DESIGN AND CONSTRUCTION MANUAL DESIGN MODIFICATION REQUEST

PROJECT NAME: The Ridge at Winterset Summit – PDP and Rezoning

PERMIT NUMBER: Application Number: PL2020219

Watershed Map
Construction Plans for:
Winterset Cedar Creek
Lee's Summit, Jackson County, Missouri

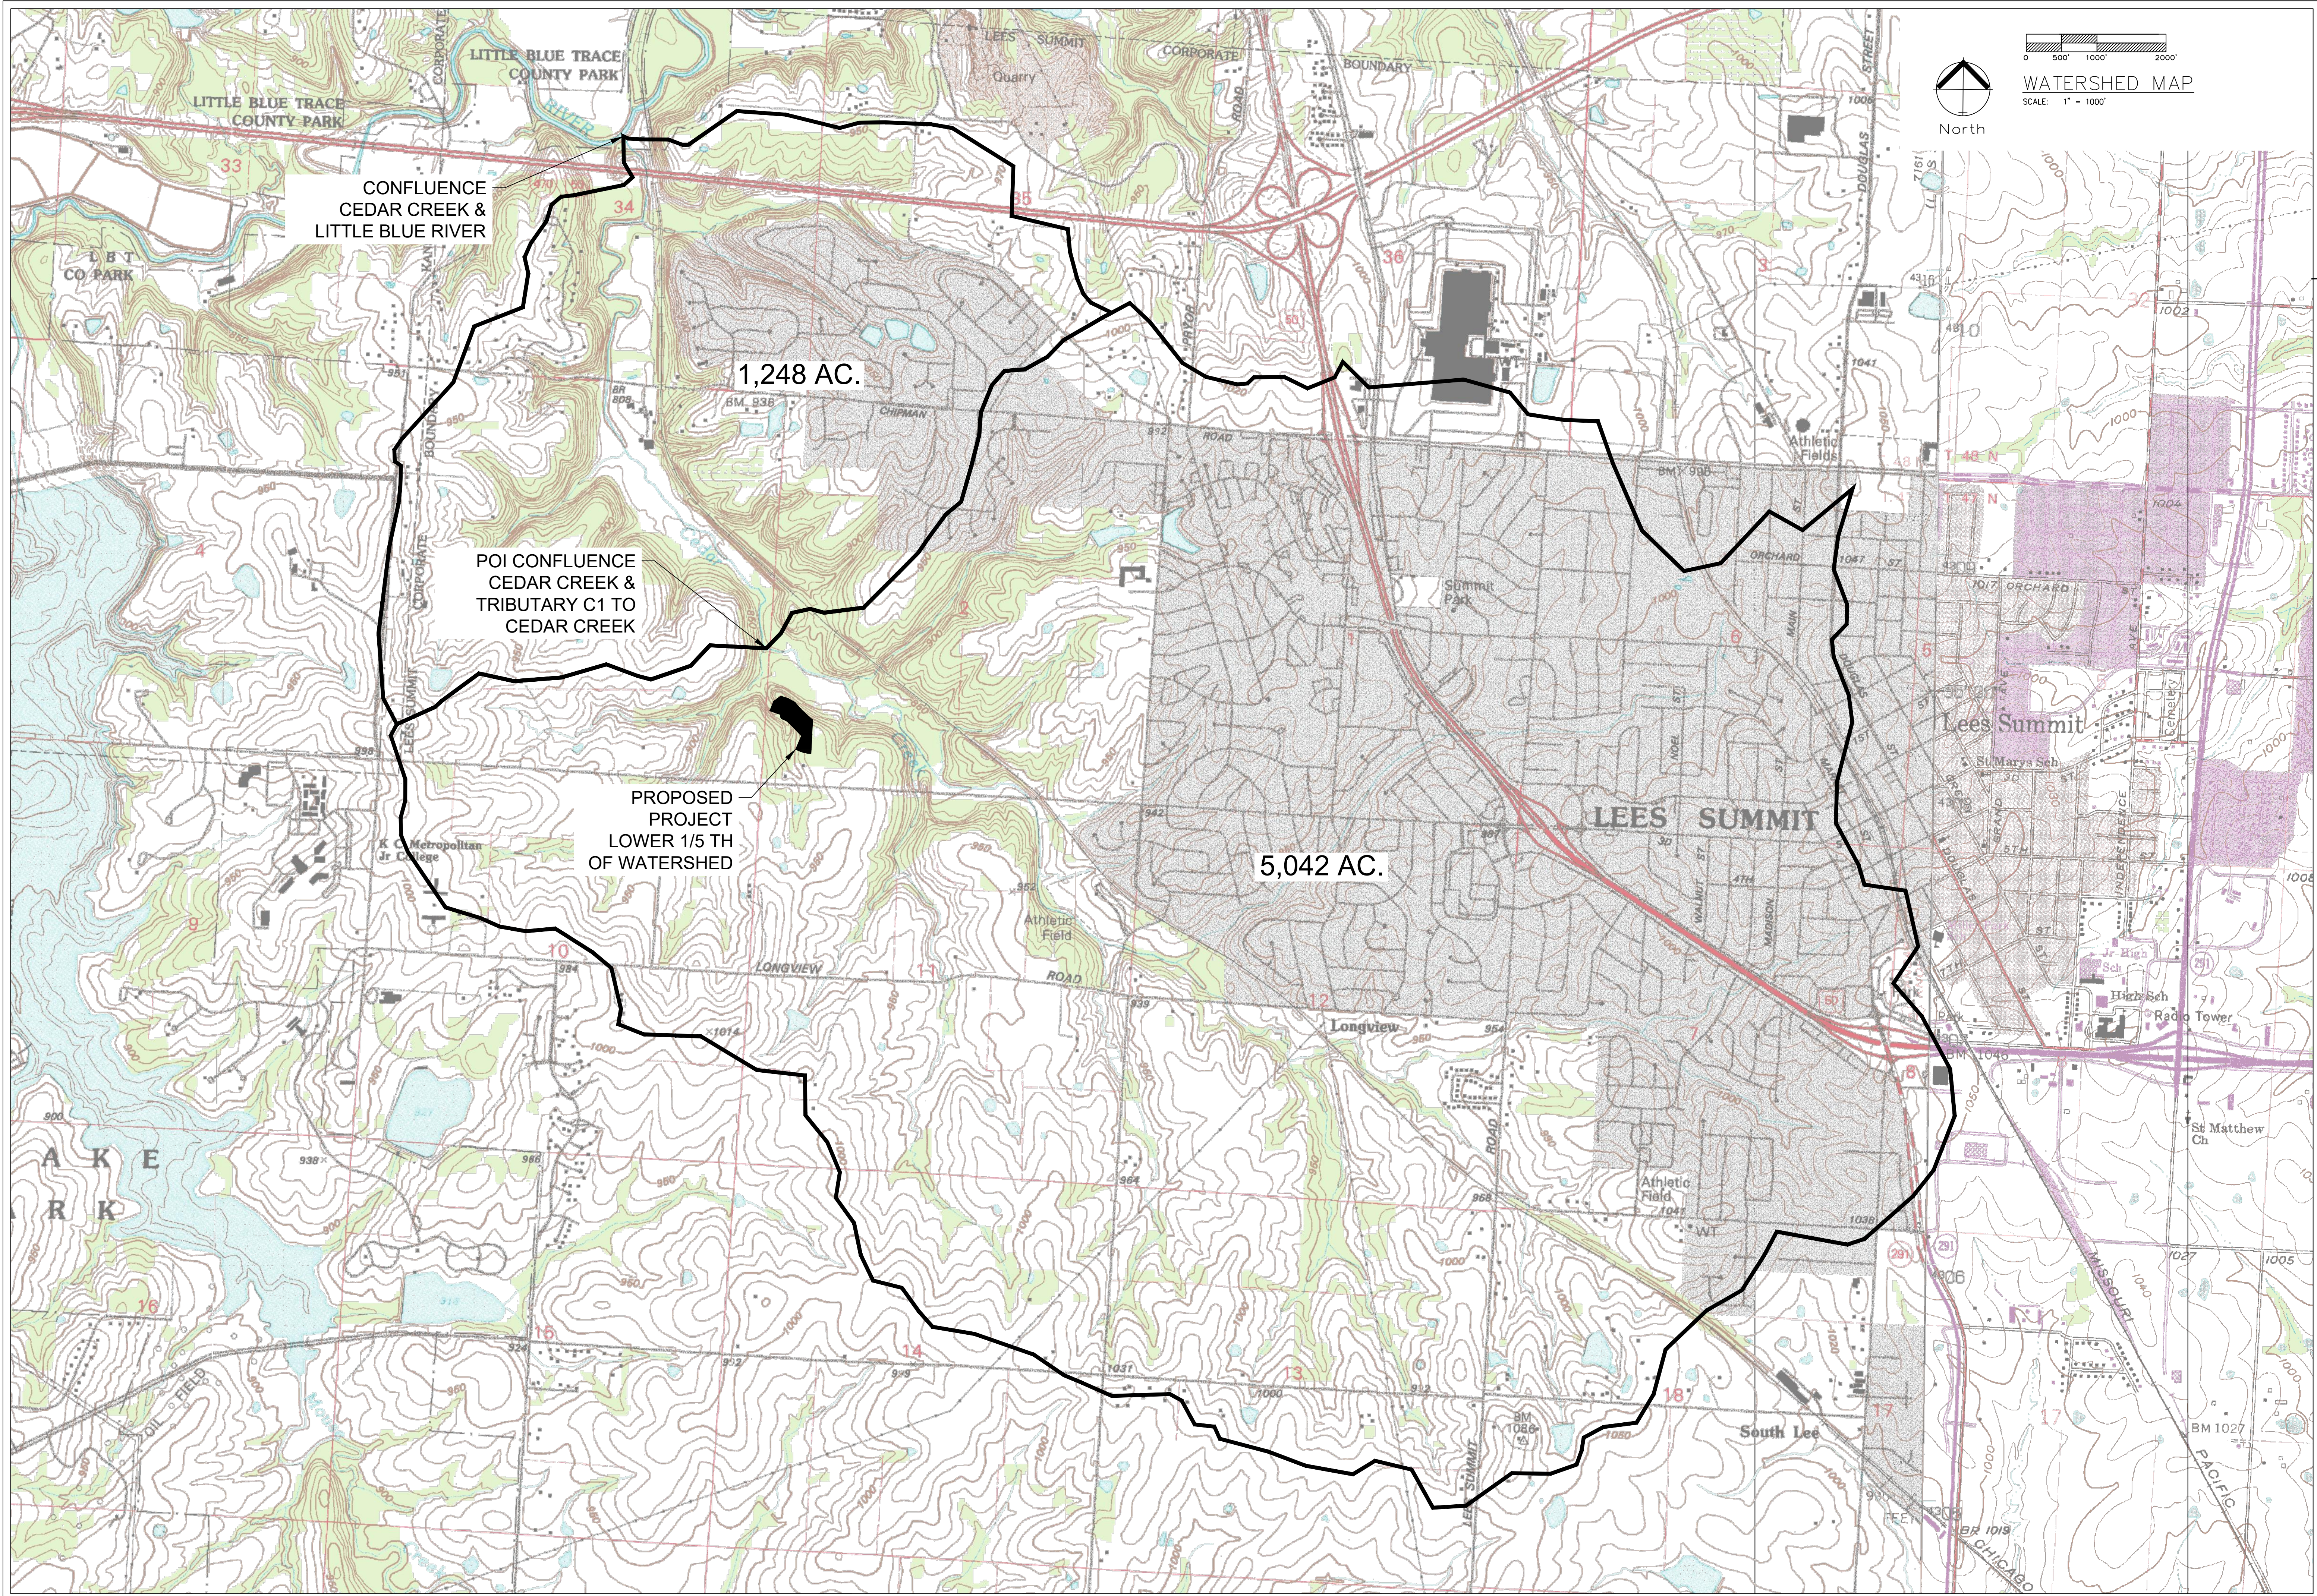
1. KCAPWA Section 5608 Stormwater Detention and Retention, 5608.4 Performance Criteria, C. Release Rates, 1. Comprehensive Control, a. Post-Development Peak Discharge Rates for the 50%, 10% and 1% Storms. We request this criterion be waived based on the following, the post development peak discharge rates will be reduced below existing for all regulatory design storms including the 1.37" water quality storm. The peak discharge reduction occurs due to the reduction in the time of concentration for the proposed development in relation to the remainder of the upstream watershed which remains constant. The following table summarizes the existing and proposed peak discharge rates at the Point of Interest.

A watershed map depicting the proposed project site, the Point of Interest and the watershed boundary is attached for reference. Both the watershed map and data presented were taken from the macro storm water drainage study titled, "The Ridge at Winterset Summit" dated October 27, 2020.

2. KCAPWA Section 5608 Stormwater Detention and Retention, 5608.4 Performance Criteria, C. Release Rates, 1. Comprehensive Control, b. 40-hour Extended Detention. We request this criterion be waived based on the peak discharge reduction as outlined in the table above in addition to the minimal volume being captured by the enclosed storm sewer system due to the topography and strata of the subject property. The majority of stormwater runoff will drain via sheet flow from the rear yards of lots to either Cedar Creek or Tributary C1 to Cedar Creek. The project site nearly meets the "design exception" for an area 2 acres or less, and an increased impervious area of 10% or less. Gale Communities specifically the Winterset Valley Development adjacent to the proposed project includes several BMP water quality entities such as numerous Butterfly/Rain Gardens throughout the development along with a large vegetated swale designed to help infiltrate and improve overall stormwater quality.
